RE: EF III Building Design Update (SP #328)

### EF III DESIGN UPDATE . MUSEUM WAY VIEW

# EF III DESIGN UPDATE . MUSEUM WAY VIEW COMPARISON

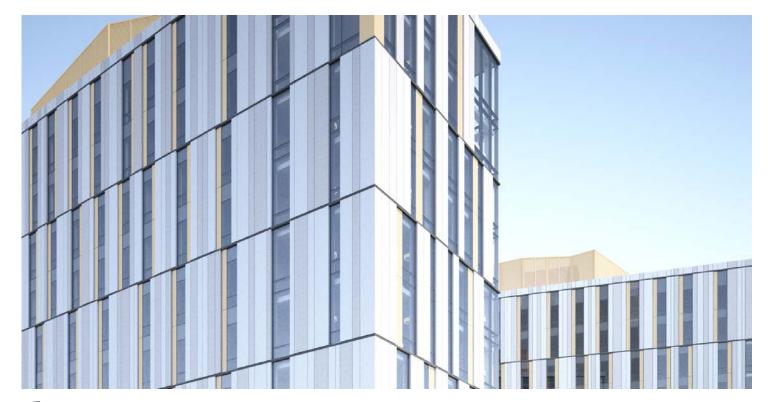
- With a focus on creating an indoor/outdoor connection, we have specified
  a charcoal mullion at the base level to create an emphasis on the interior
  colors and spaces.
- This refinement in the design helps to emphasize the different components of the building: base, middle, top.
- The sandblasted precast at the base works well in conjunction with the charcoal mullion and helps to conceal the metal louvers.

Charcoal Mullions at Building Base

**Charcoal Mullions**

**Gold Mullions**
